**NOTICE TO BIDDERS**  
**LETTING OF NOVEMBER 9, 2018**  
**ADDENDUM NO. 1**

**CITY OF HANCOCK – NOTICE TO BIDDERS – ADDENDUM**

**PROJECT:** 204835 – Montezuma Blvd. (DDIR Han-5) **LETTING OF:** November 9, 2018 1:00 p.m.

**ADDENDUM: 1**

**CITY OF HANCOCK**  
**MONTEZUMA 2018 HANCOCK STORM DAMAGE RECONSTRUCTION**  
**REMOVALS**  
POB 200+35 - POE 203+16

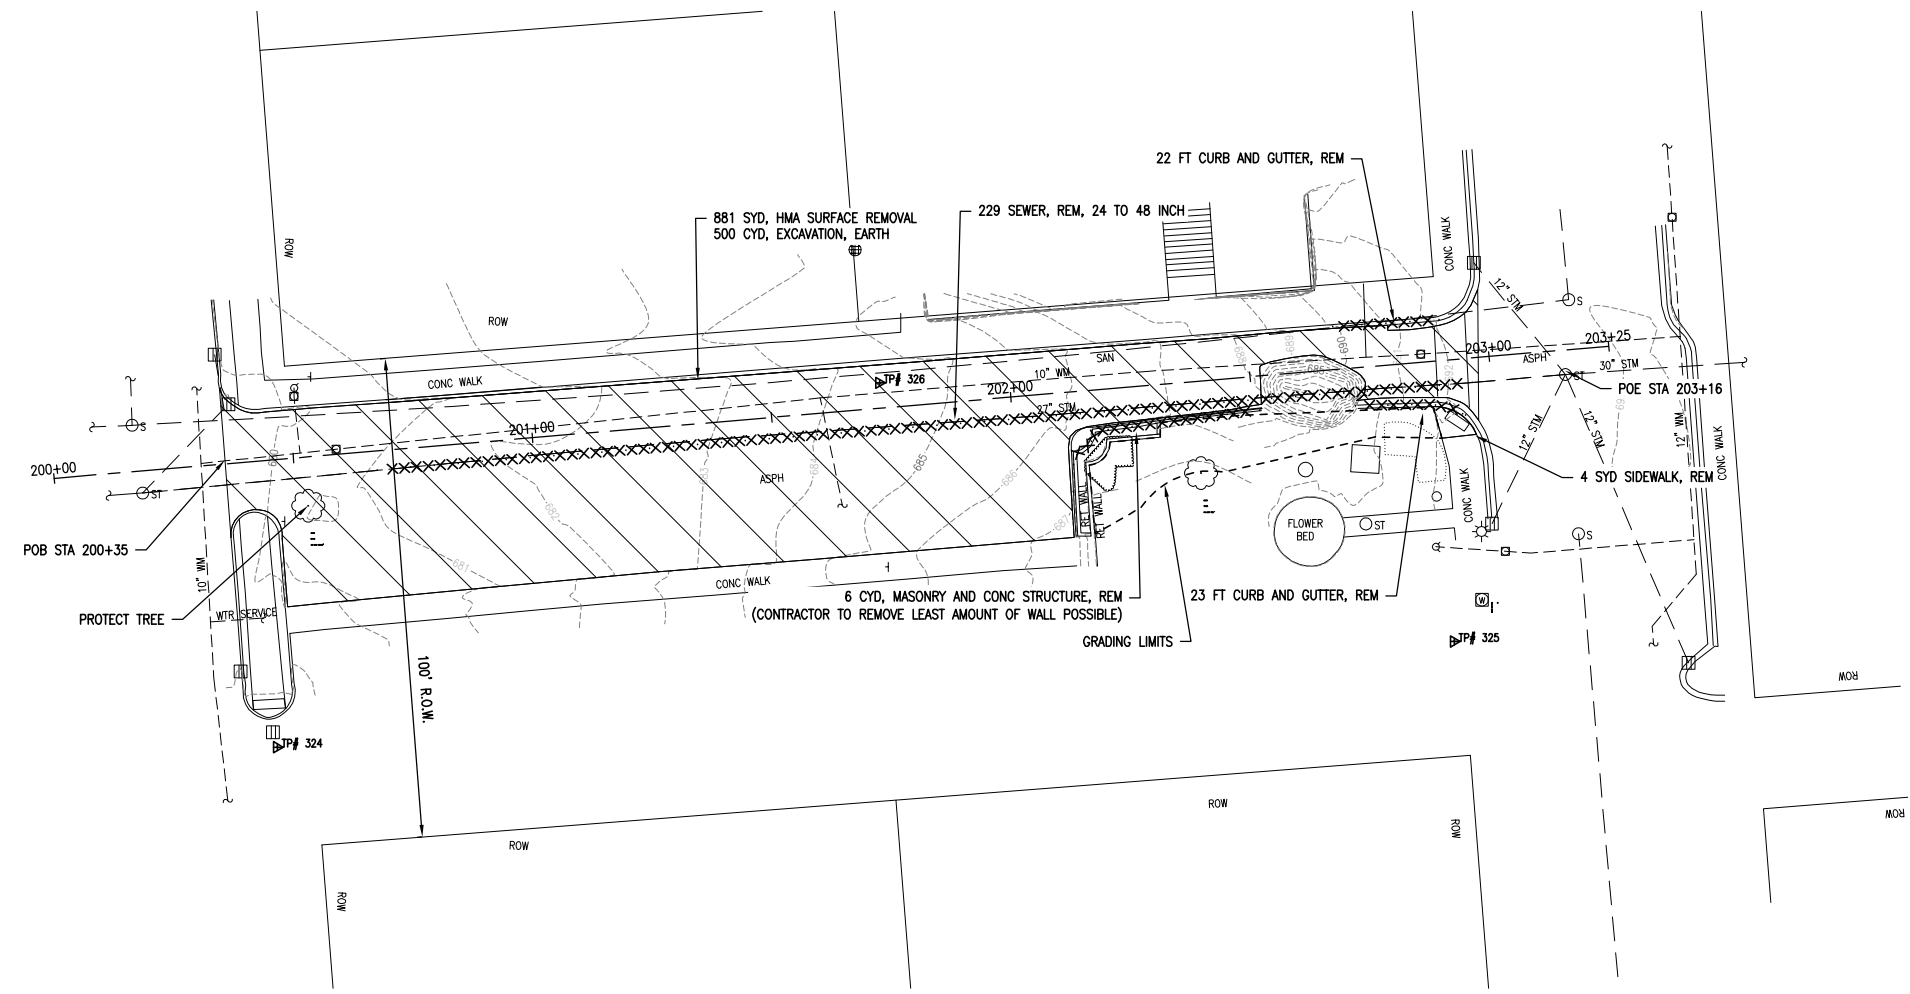
1) On Page 6, revise the drawing scale to the correct scale. Attached is an updated drawing.

CITY OF HANCOCK  
MONTEZUMA 2018 HANCOCK STORM DAMAGE RECONSTRUCTION  
PROPOSED AND PROFILE

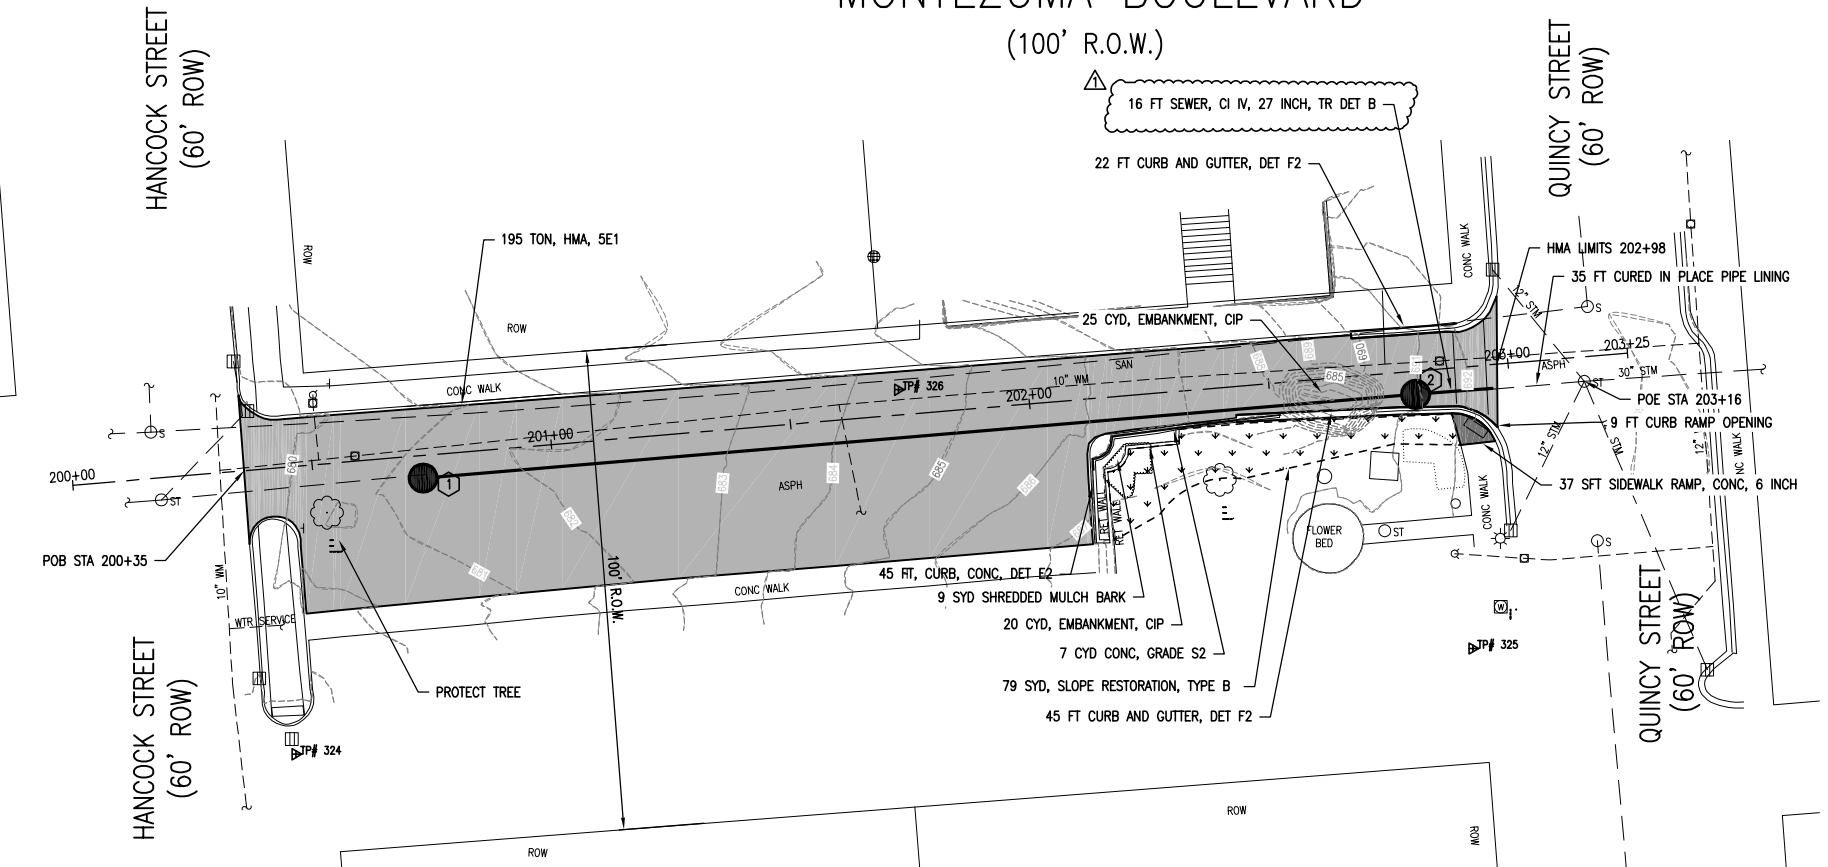
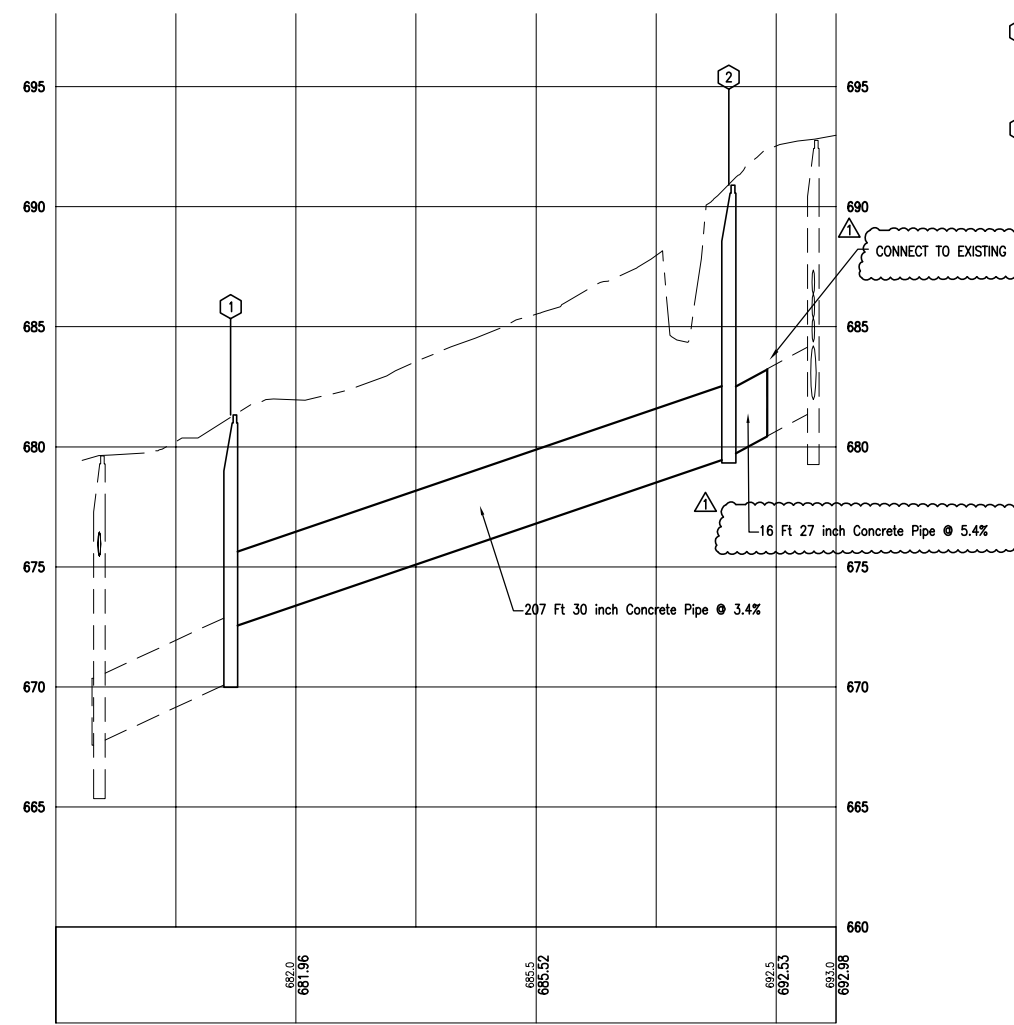
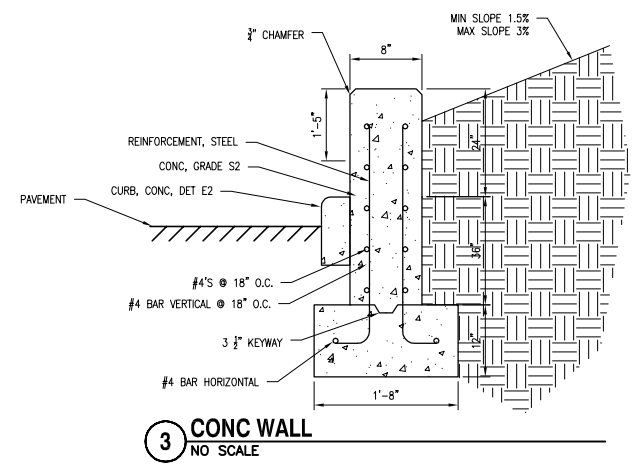
2) On Page 7, revise the drawing scale to the correct scale. Revise the replacement of storm sewer upstream of MH Structure 2 to “\_Sewer, CI IV, 27 inch, Tr Det B” from the previous “Sewer, CI IV, 30 inch, Tr Det B”. Attached is an updated drawing.

- ① STA 200+72.82, 4.7' R  
5' PRECAST CONCRETE WITH TYPE B COVER  
T/CAST 681.33  
27" INV S 670.48  
30" INV N 672.75
- ② STA 202+80.29, 4.8' R  
5' PRECAST CONCRETE WITH TYPE B COVER  
T/CAST 690.90  
30" INV S 679.83  
27" INV N 679.84
